**Transport
for NSW**

Exhibition of Preferred Project Report supporting Project Application for Rozelle Village/Balmain Leagues Club Development off Victoria Road, Rozelle (MP11_0015)

Parsons Brickerhoff Rozelle Village Paramics Model Audit

Peer review of Rozelle Village Paramics Modelling

Figure 4.2 Inconsistent road category coding

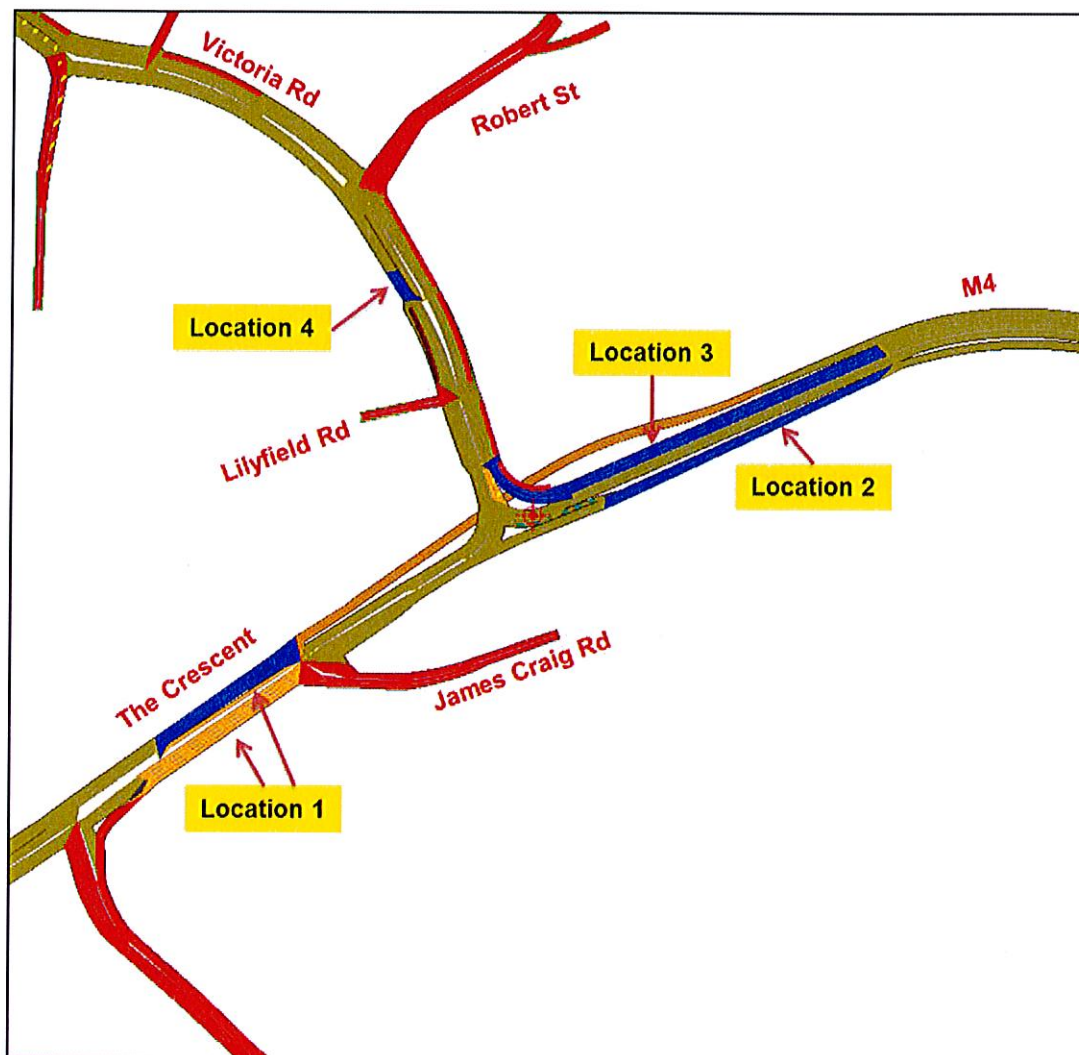
Inconsistent category link coding was observed in a number of locations in the base models as shown in Figure 4.2:

- **Location 1:** The Crescent (in both directions) between Victoria Road and City West Link was coded as inconsistent categories (category 32 and 33 vs 49, 50, 56 and 61) with different category speeds
- **Location 2:** M4 Western Distributor Freeway between ANZAC Bridge and The Crescent was coded as inconsistent categories (category 32 vs 49 and 75)
- **Location 3:** Victoria Road (eastbound) between Lilyfield Road and ANZAC Bridge was coded as inconsistent categories (category 77 vs 50 and 55)
- **Location 4:** Victoria Road (northbound) between Lilyfield Road and Robert Street was coded as inconsistent categories (category 76 vs 50).

Recommendation: Links should be coded with consistent categories along similar lengths of road. Category cost factors should be consistent for roads at the same level in the road network hierarchy; link cost factors should be used for route cost calibration.

Figure 4.3 Signal coding error

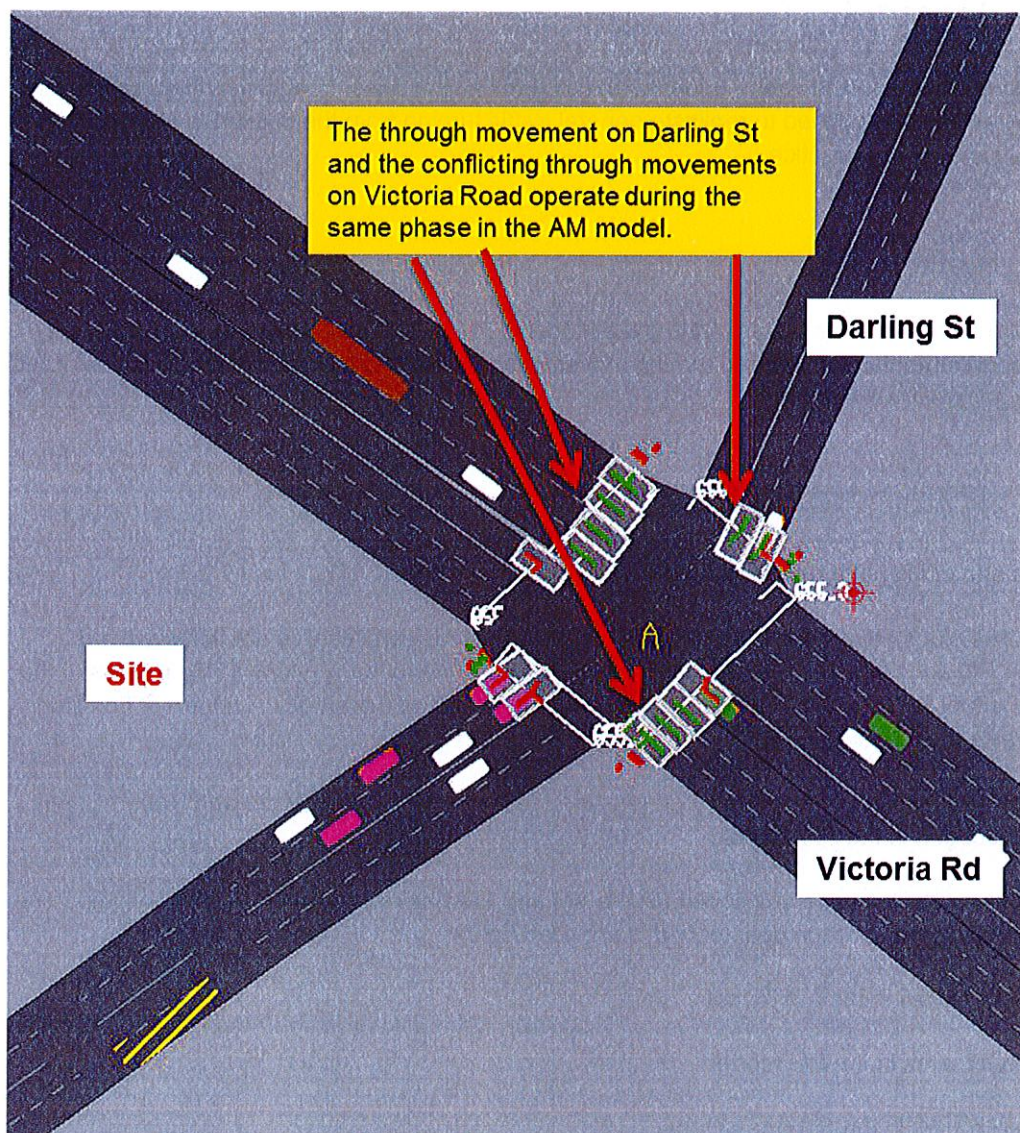
A review of signal operations in the model reveals the following error as shown in Figure 4.3:

- The through movement on Darling Street run simultaneously with the conflicting through movements (in both directions) on Victoria Road in the AM base model.

This coding error is likely to have significant impact on the performance of the Victoria Road/Darling Street in the vicinity of the site.

Recommendation: Review the coding of signal operations in the AM model and make adjustments where necessary. Update base model calibration appropriately.

Figure 5.1 AM peak – Unreleased vehicles on Wellington Street and Evans Street

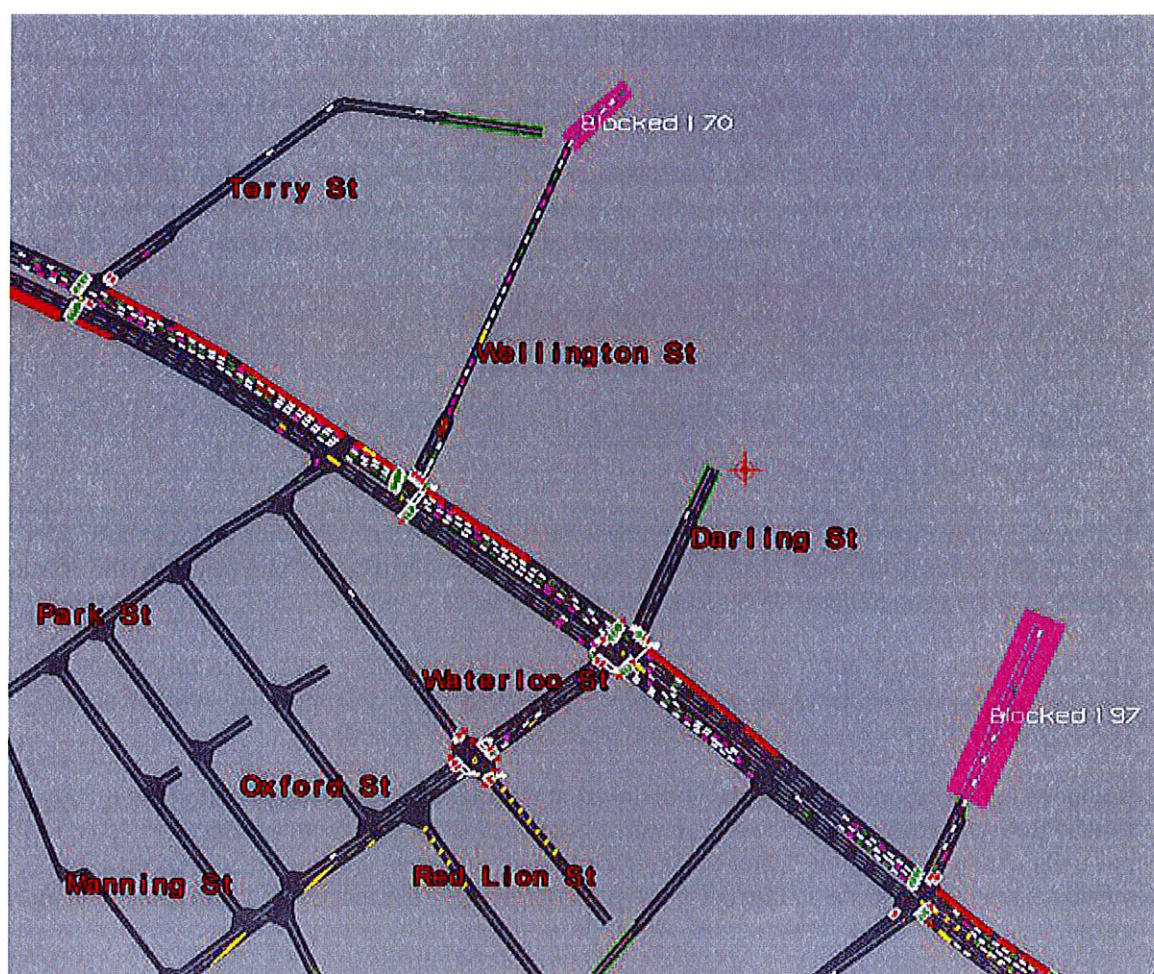
No queue length calibration/validation was undertaken on any of the side roads off Victoria Road. Several side roads in the base models show extensive queuing, which in some cases extends back into the zone, leading to high numbers of unreleased vehicles.

The delay on the side roads may be underestimated as the unreleased demand is not included in the downstream intersection delay calculations. Figure 5.1 shows 170 unrealised vehicles at Wellington Street and 197 vehicles at Evans Street during the AM peak.

No queue length calibration has been undertaken at the intersection of Waterloo Street and Darling Street. Given that Waterloo Road will be a key access/egress route to/from the development, the queuing on Waterloo Street and Darling Street should also be considered in the model calibration/validation so that the impacts can be suitably assessed with the development in place.

Recommendation: Queuing on the key side roads (including, Terry Street, Darling Street, Evans Street and Robert Street) should be included in the model calibration/validation and numbers of unreleased vehicles reported for each model run (by zone). Alternatively the network should be extended to reduce the number of unreleased vehicles and to capture the true delay experienced on these side roads. A queue length calibration exercise should be undertaken at the Waterloo Road/Darling Street intersection.

Figure 6.1 Signal timings at Victoria Road/Wellington Street, Base and Proposed

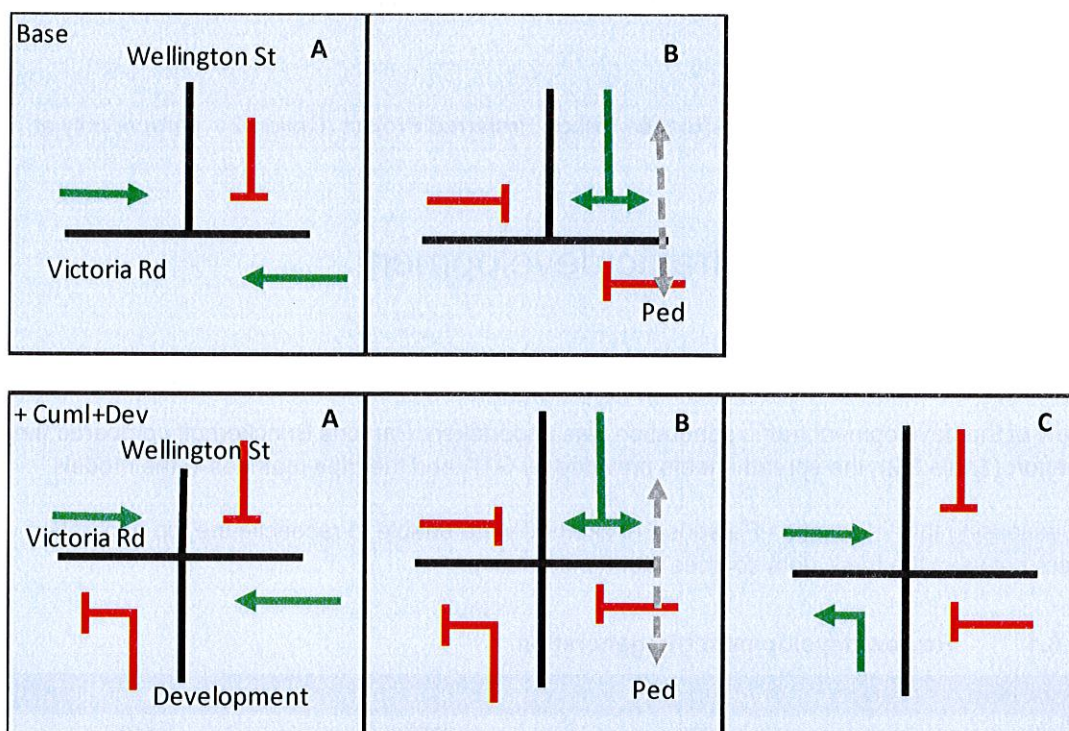
In order to accommodate the development access, a fourth leg has been added to the Wellington Street/Victoria Road Intersection. An additional 'Phase' has been added to the traffic signals to allow traffic to egress the site (left only). Figure 6.1 shows the Base case signals phasing and the revised phasing with the Rozelle Village Development in place.

Table 6.2 shows the green time allocation for the base case modelling and with the development in place. The table highlights that green time for Wellington Street is reduced in all three peaks when the fourth leg is introduced. The Westbound movement on Victoria Road also reduced in all three scenarios.

The base models show that there is currently extensive queuing on Wellington Street with up to 170 unreleased vehicles blocked in the zone (during the AM peak). By reducing the green time for Wellington Street, the queuing increases, as does the number of vehicles blocked in the zone. In the AM peak the number of unreleased vehicles exceeds 200 vehicles.

The GTA report shows that the Level of Service at this intersection does not change greatly with the development in place, going from LOS F with a Delay of 152 Seconds in the AM Base Case to LOS F with a delay of 154 Seconds with the development in place (Appendix C), however the delay on Wellington Street is only calculated for vehicles which are able enter the network, and does not capture the delay for the unreleased vehicles within the zone. Therefore the results are significantly underestimating the impact of the development at this intersection.

Figure 6.2 Signal timings at Victoria Road/Wellington Street

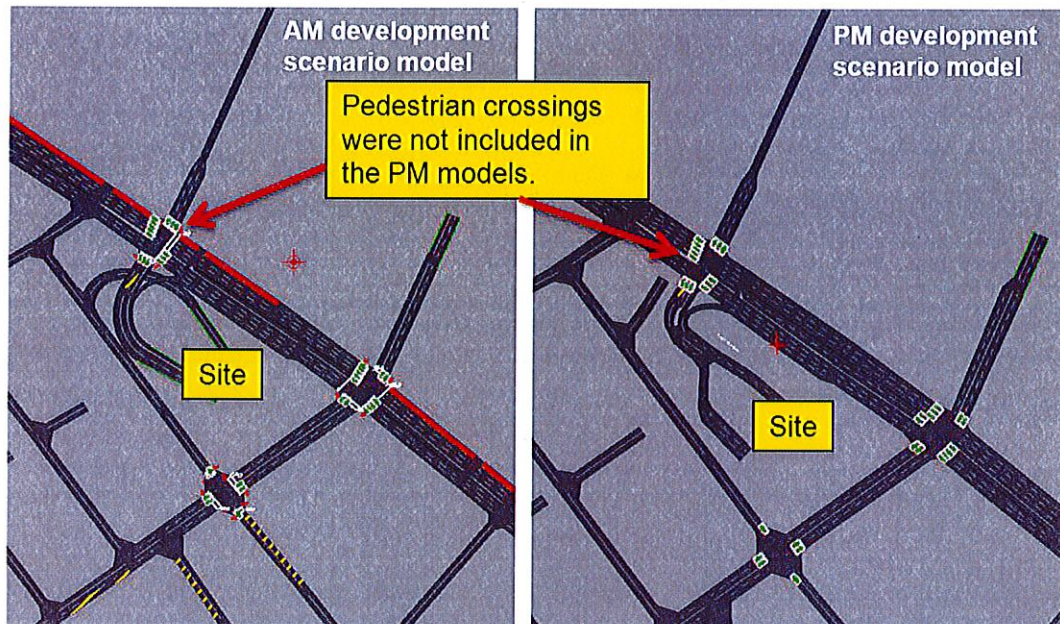
A pedestrian crossing has been included in the AM peak and Saturday peak models but not in the PM peak model. No justification is provided as to why a pedestrian phase has not been included during the PM peak.

Recommendation: Include a Pedestrian Crossing in the PM Models.

Figure 6.3 Coding error at Robert Street

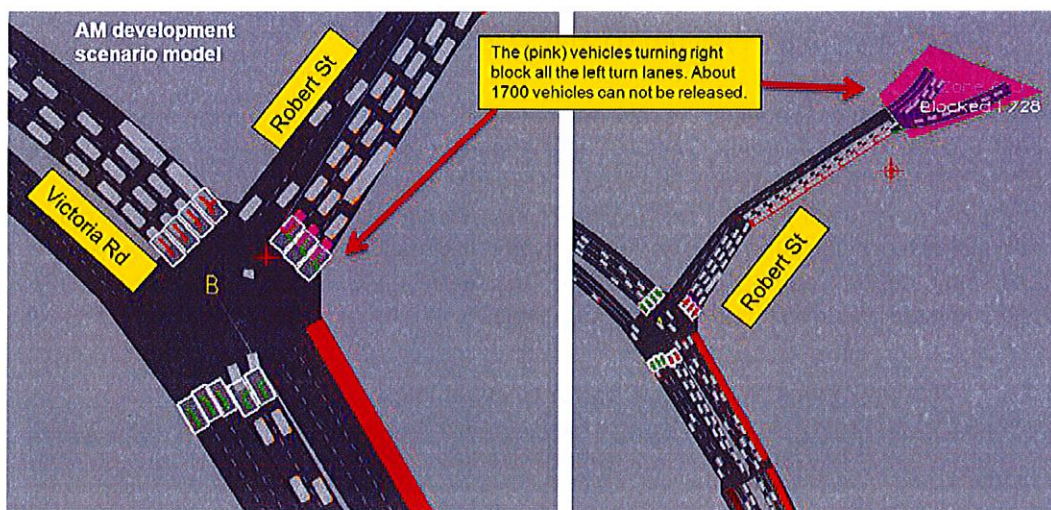
In the AM peak model (with the Rozelle Village development in place), nine trips have been assigned from Robert Street (Zone 13) to the Rozelle Village development. During the AM peak the right turn from Robert Street into Victoria Road is banned. Because the banned turn is defined at a signalised intersection, the nine trips are released onto the network. These trips are subsequently unable to turn right at the intersection of Robert Street/Victoria Street eventually blocking all traffic from exiting Robert Street (this generally occurs about 30 minutes into first peak hour). With no traffic able to exit Robert Street, there are over 1,700 unreleased vehicles by the end of the second peak hour.

The results of the AM peak modelling are severely impacted by this issue. The results presented in the GTA report show that the 'Base +Cumulative+ Rozelle Village Scenario' actually improves network operations when compared against the AM base case scenario. Table 4.5 in the GTA PPR shows the LOS at Robert Street/Victoria Street goes from LOS F in the Base to LOD D with the development in place. This is because so much so much traffic is unreleased onto the network and Victoria Road operates much better as a result.

Recommendation: This issue need to be fixed and the AM peak models rerun. All AM peak reporting (with the development in place) will need to be undertaken again.
